STATE OF NORTH CAROLINA  
DEPARTMENT OF TRANSPORTATION

SUBJECT: Supplemental Information to the **Regional General Permit 31 and Section 401 Water Quality Certification** for the proposed widening of NC 146 (Long Shoals Road) from west of SR 2501 (Clayton Road) to east of I-26 in Buncombe County. NCDOT Division 13, Federal Aid Project No. STP-146(5), TIP No. R-2813B. Debit WBS Element 34505.1.1.

REFERENCE: USACE Section 404 Regional General Permit 31 No. SAW2007-3084-311 issued 11/19/2007.

NC Div. of Water Quality Section 401 Certification No. 20070124v.5 issued 10/22/2007.

PROJECT REFERENCE NO.	SHEET NO.
R-28138	6A
R/W SHEET NO.	
ROADWAY DESIGN ENGINEER	HYDRAULICS ENGINEER

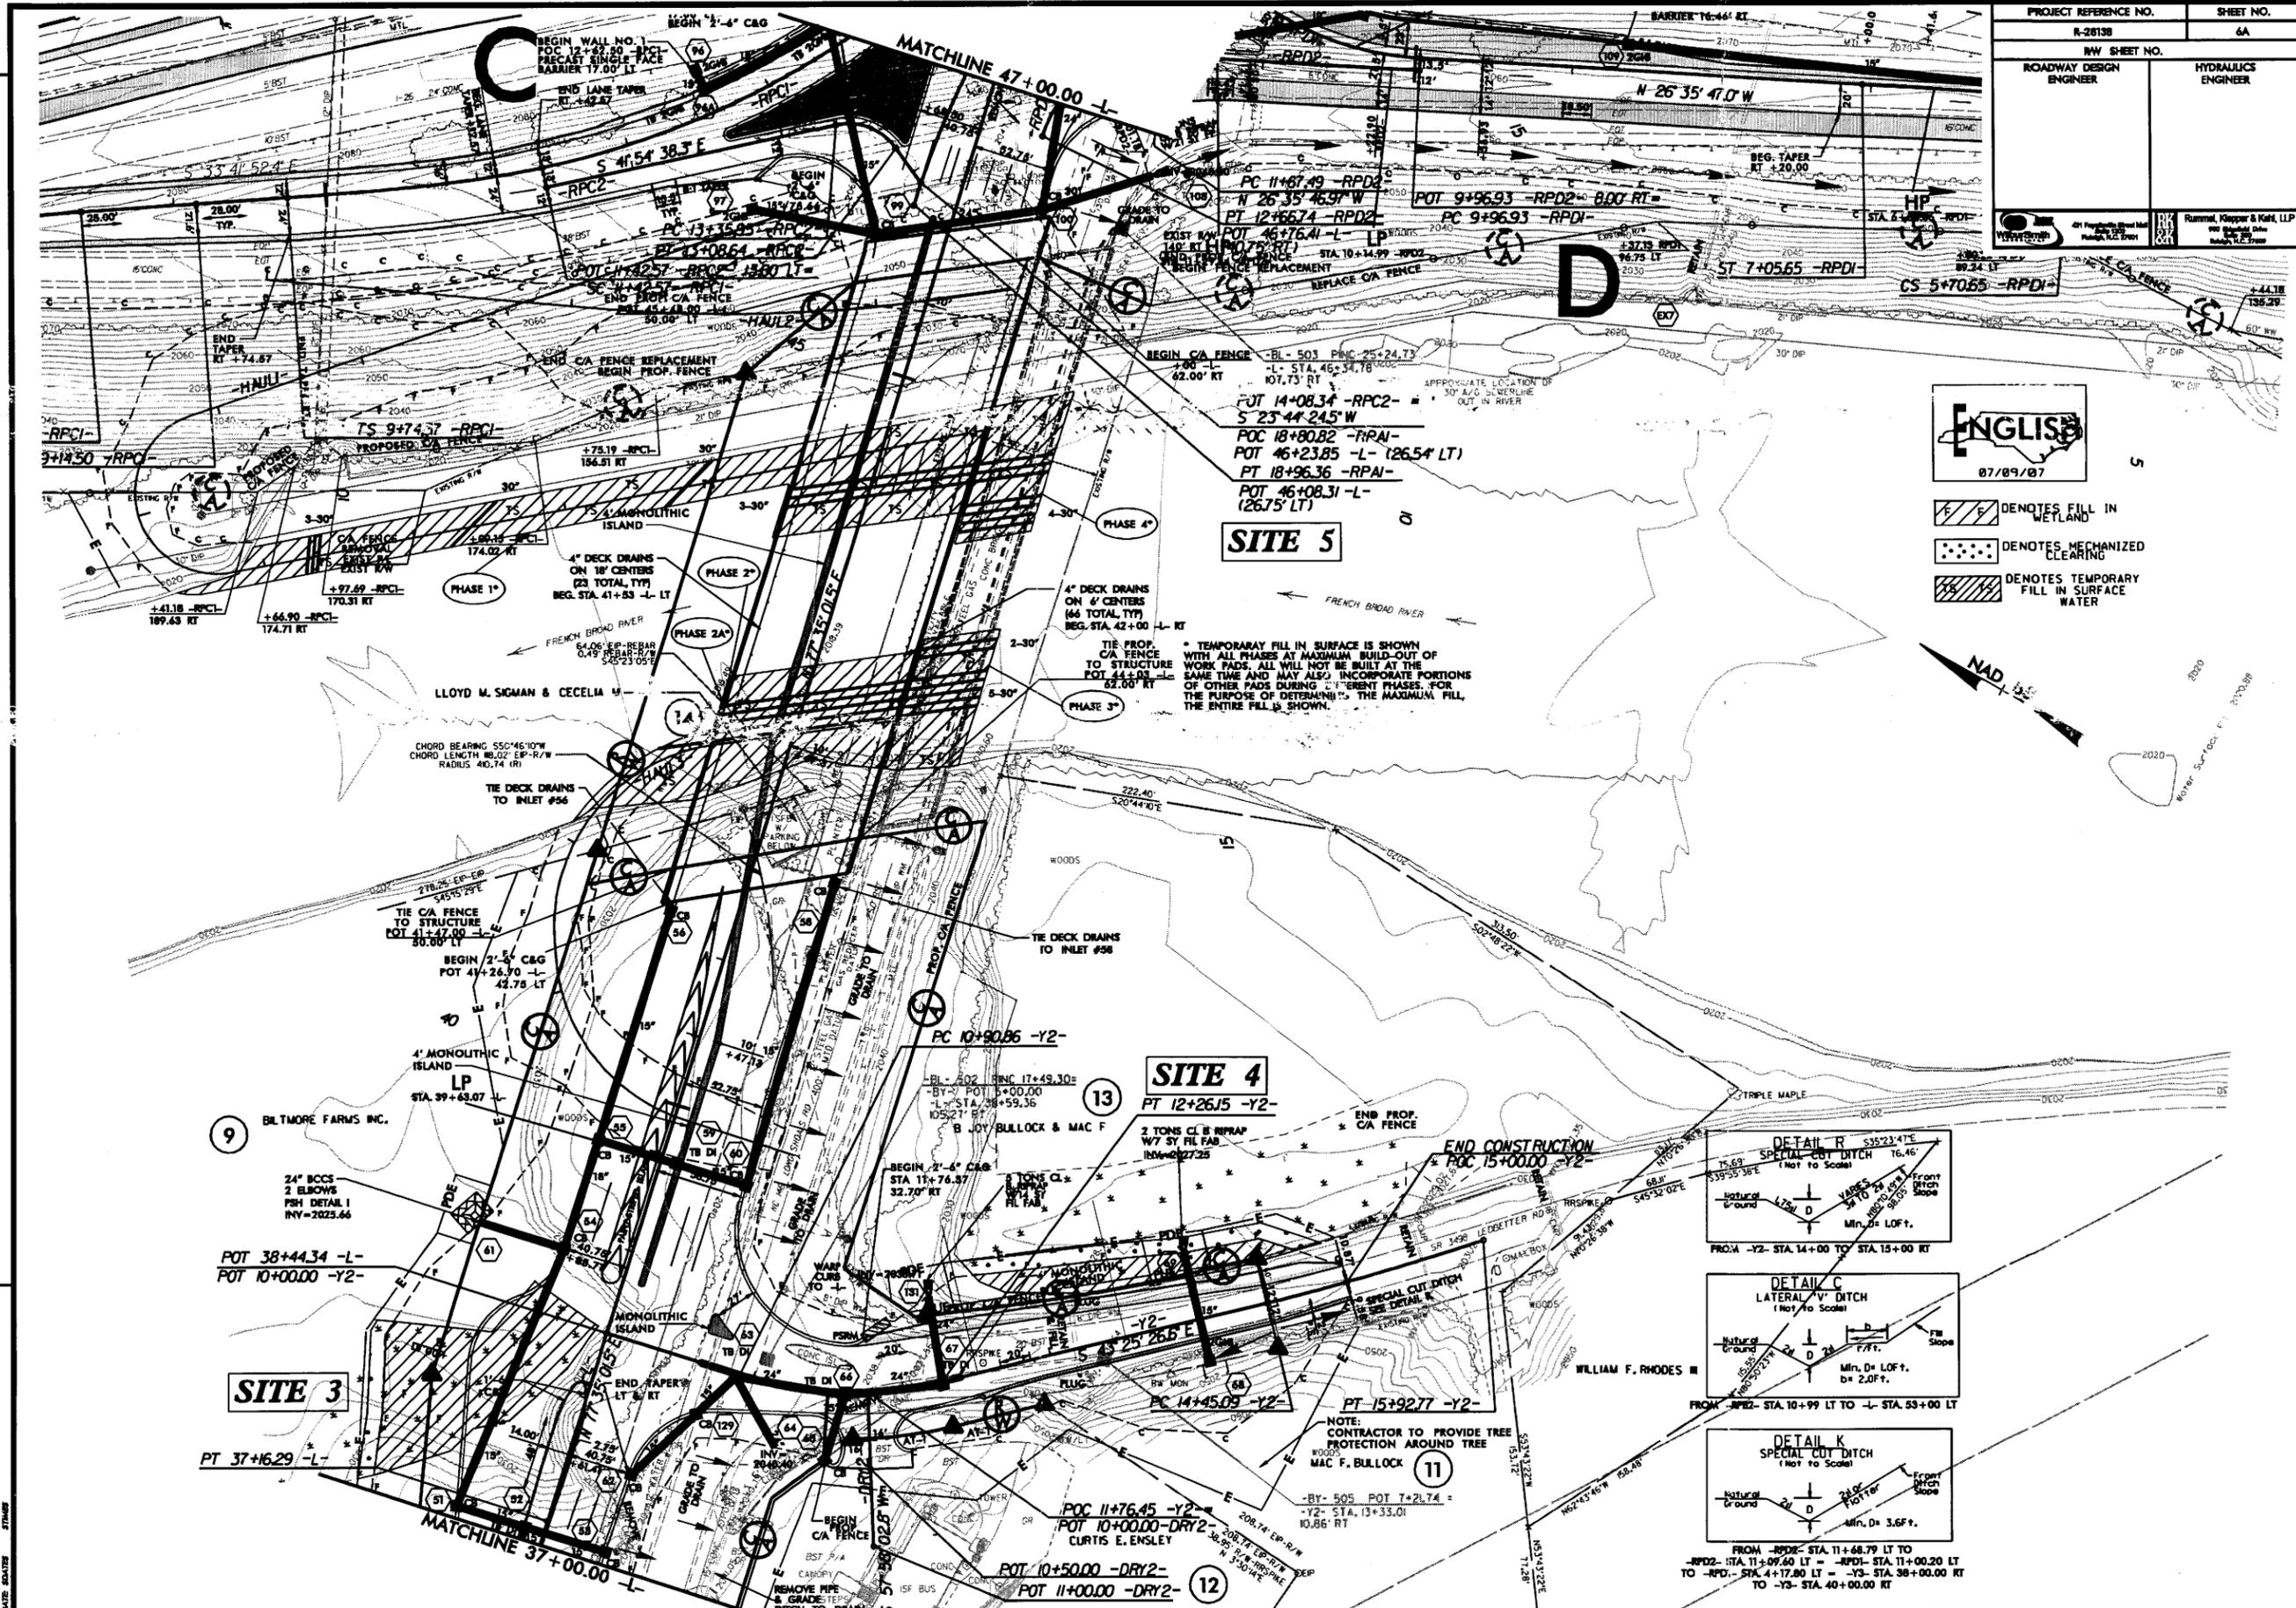
Please see the enclosed permit drawing "Sheet 6A" for the revised "Site 5" for the above referenced project. Per our phone conversation on April 1, 2008, we briefly discussed the omission of this temporary impact permit drawing for the temporary work pad required to construct the bridge over the French Broad River on NC 146.

There are 5 phases (1, 2, 2A, 3, and 4) involved with the build-out of the causeways for construction of the bridge over the French Broad River. Phase "2A" (as found on Sheet 6A) was inadvertently left off of the original permit application. This sub-phase results in an increase in temporary fill by 0.04 acre (from 0.80 to 0.84 acre). Therefore the total amount of temporary fill in surface water for Site 5 should be 0.84 acre for a grand project total temporary fill in surface water of 0.84 acre. The linear feet of temporary impacts, noted in the 401 certification, remains accurate.
